**RE: Sundance Construction – Beverly Hills
Conceptual Grading Plan
Engineer's Stamp Date: No Stamp Date
Hydrology File: B18D023**

Based upon the information provided in your submittal received 12/06/17, the Conceptual Grading Plan **is not** approved for Site Plan for Building Permit. The following comments need to be addressed for approval of the above referenced project:

A1 CONCEPTUAL GRADING AND DRAINAGE PLAN
SCALE: 1" = 20'

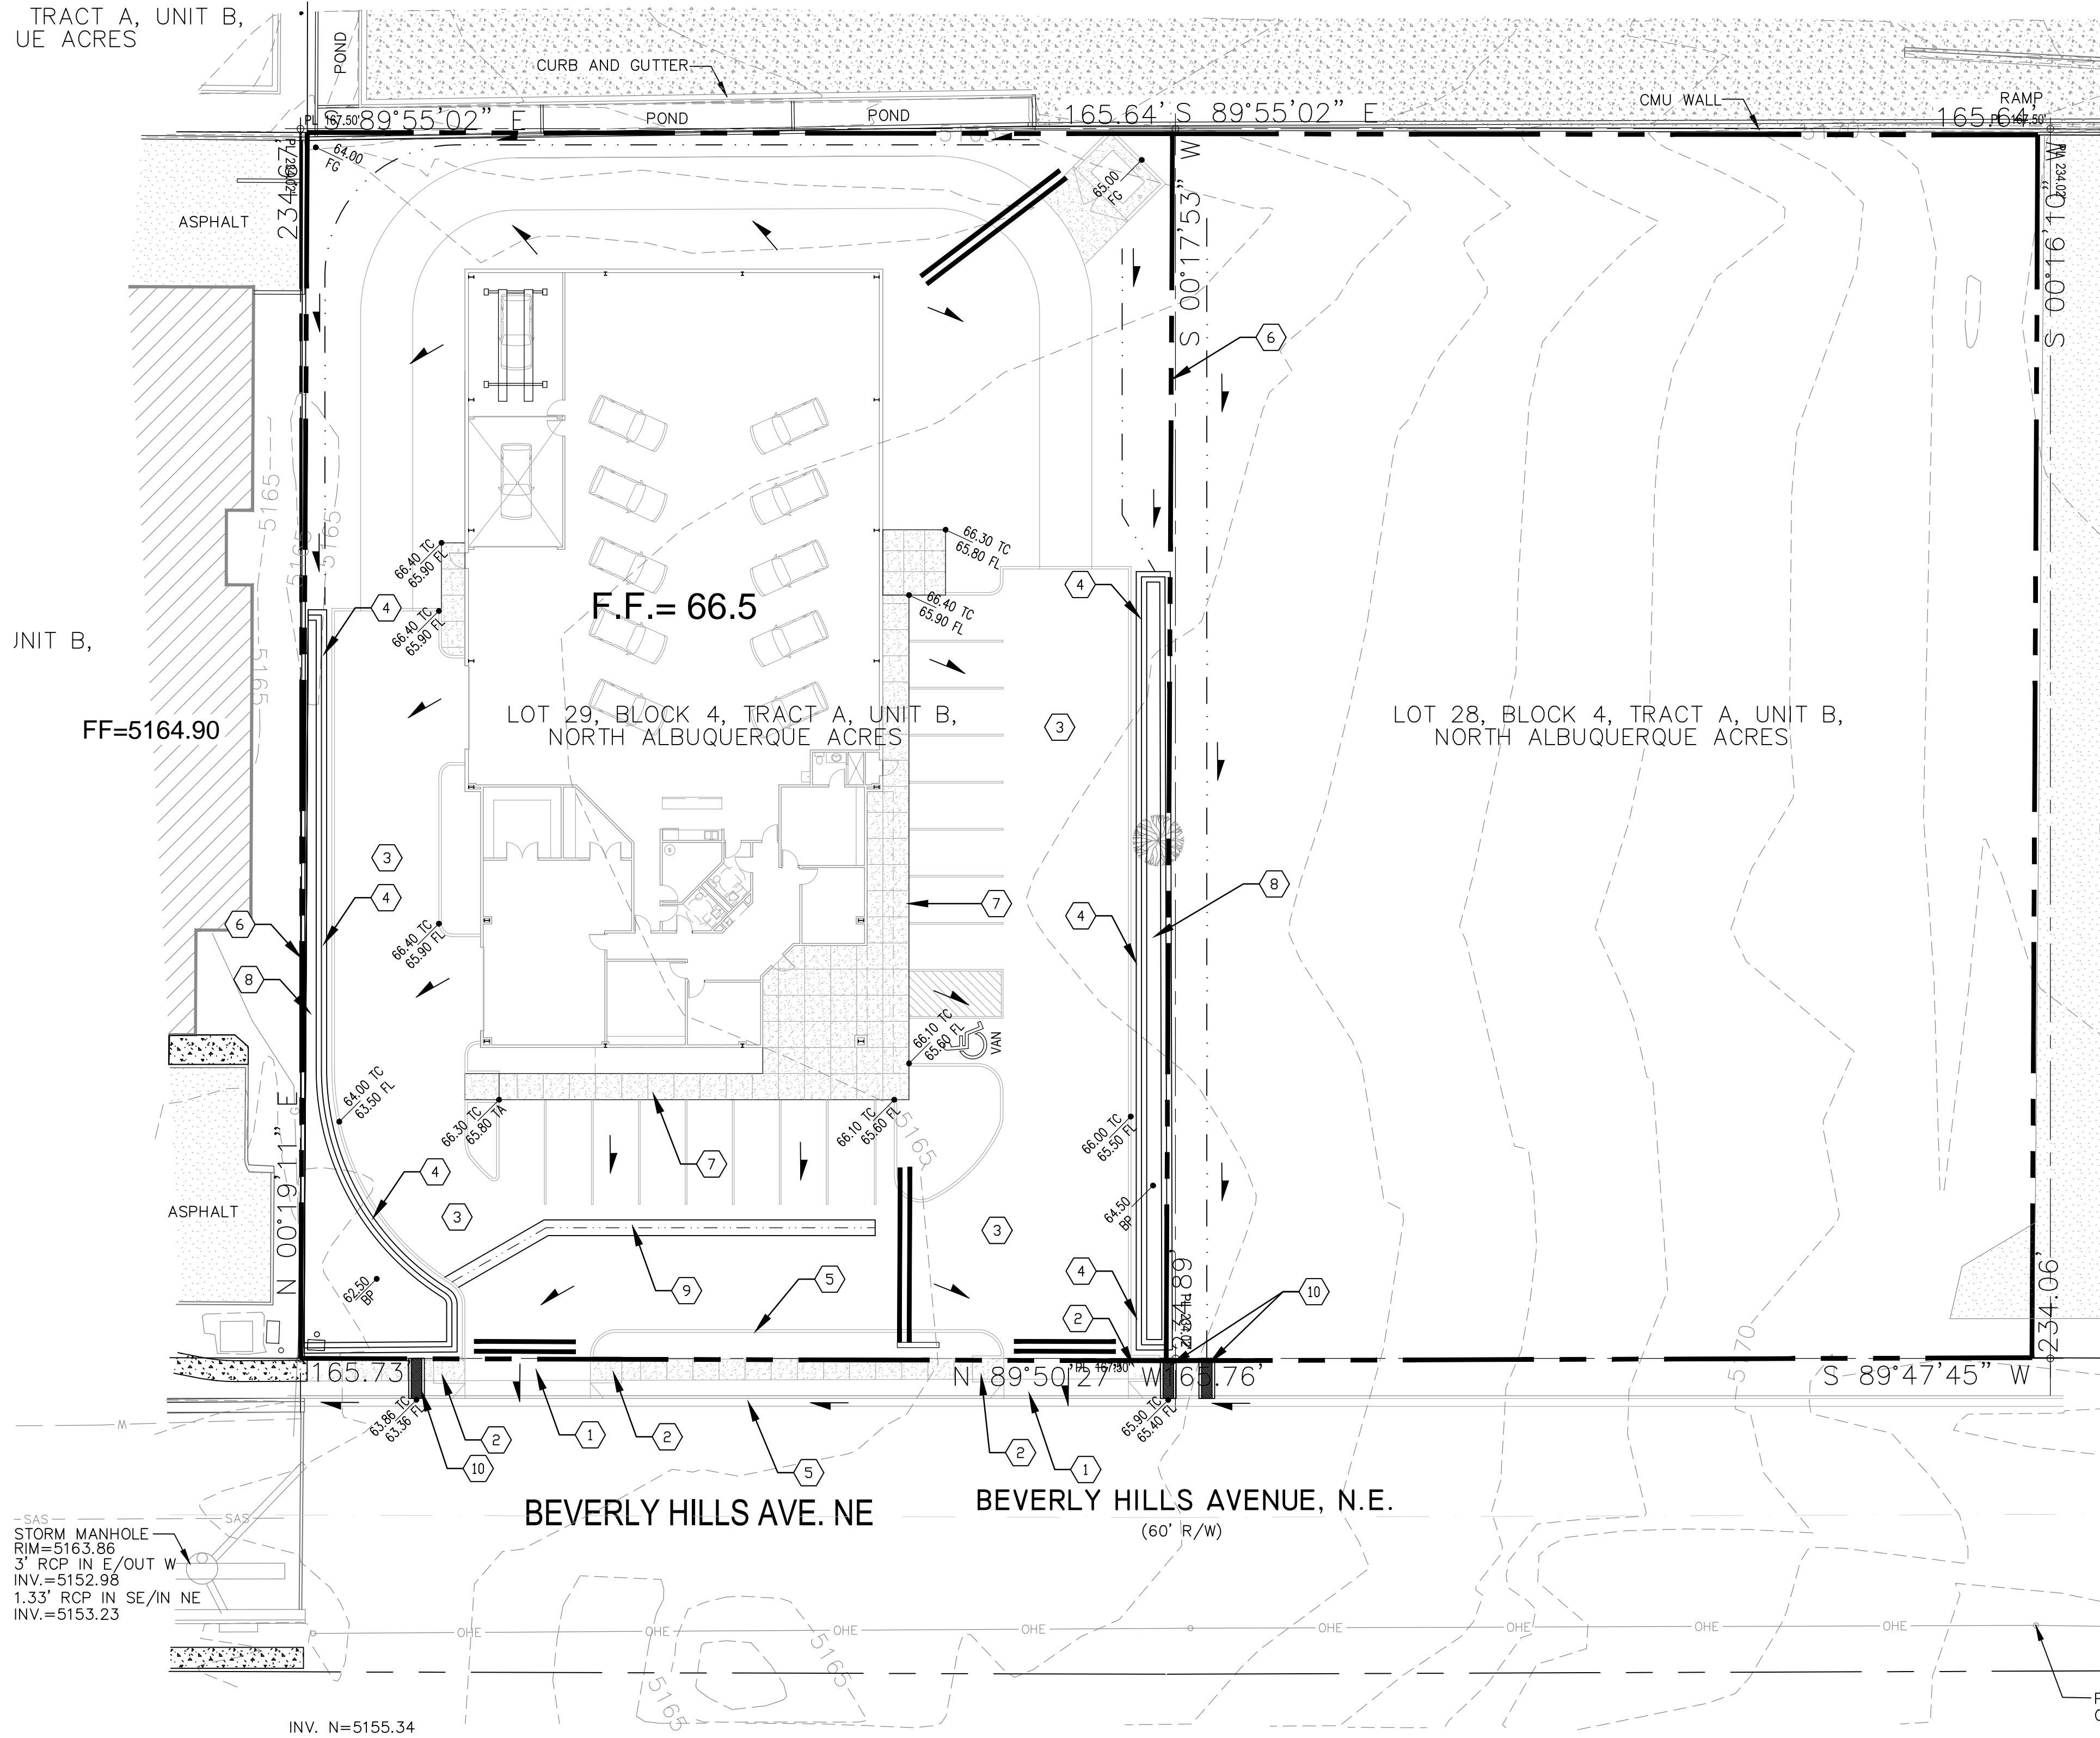
1. Please provide the FIRM Map and flood plain note with effective date.
2. Please provide a vicinity map showing the location of the site. Typically this is the Zone Atlas. This can be downloaded in pdf format from the City of Albuquerque's website.

3. Please review the upstream watershed for Beverly Hills Ave. These drainage areas should include all upstream discharges per their ultimate design. Per Chapter 22 Section 3.E (Street Hydraulics) of the DPM, the calculations are for the 10 year and 100 year storm event. The existing 36 inch storm sewer may need to be extended if future inlets are need where the future flows exceeds the street capacity. Also, the existing 18 inch storm sewer may need to be extended to the southwest corner of the tract with a new inlet. If needed, these storm sewer items will have to be included in the Infrastructure List which will be submitted during the DRB action.
